**General  
Service  
Bulletin**

**HCOM-SB-83**

**SUBJECT:** Scroll Discharge Line Failures - Review and Clarification

FIGURE 1

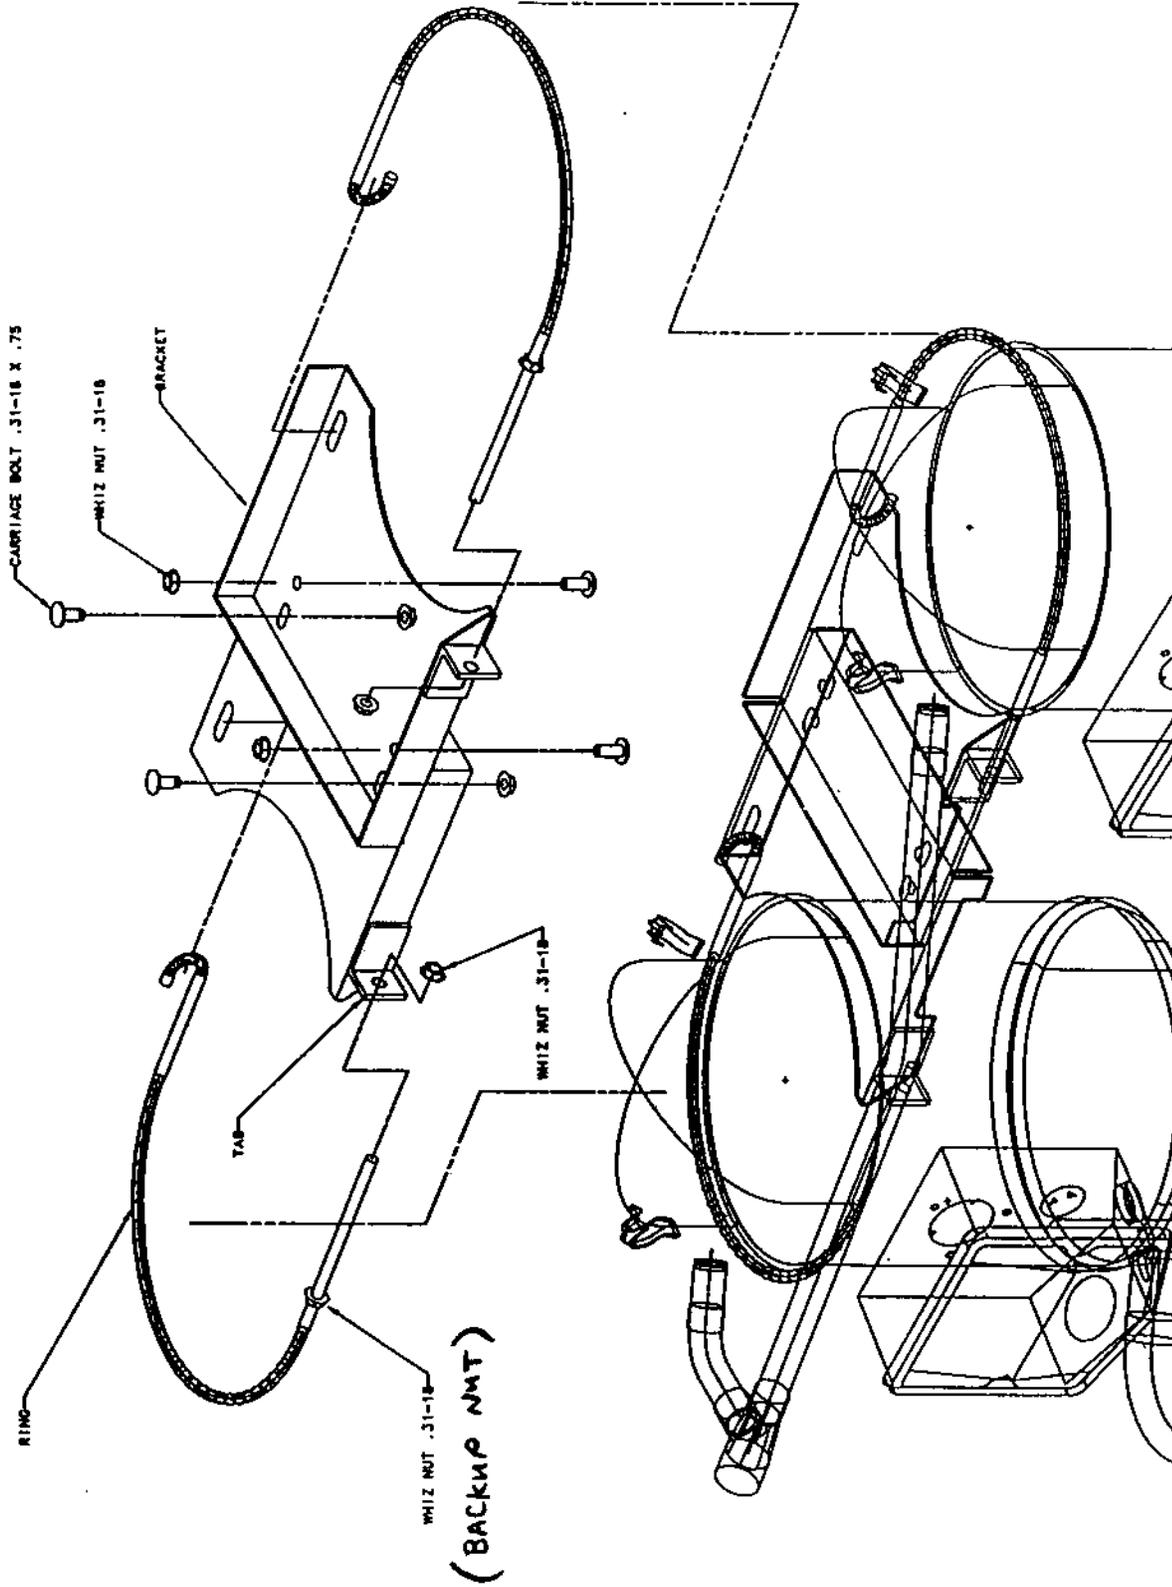
- (a) If brackets are installed, make sure they are correctly installed. Refer to Figure 1. Particular items to check include:
- proper orientation of the brackets
  - tightness of bolts
  - installation of the BACKUP NUT on the ring
  - all (4) bolts are installed

More detailed drawings and installation instructions for the field-installed brackets can be found in HCOM-SB-79B.
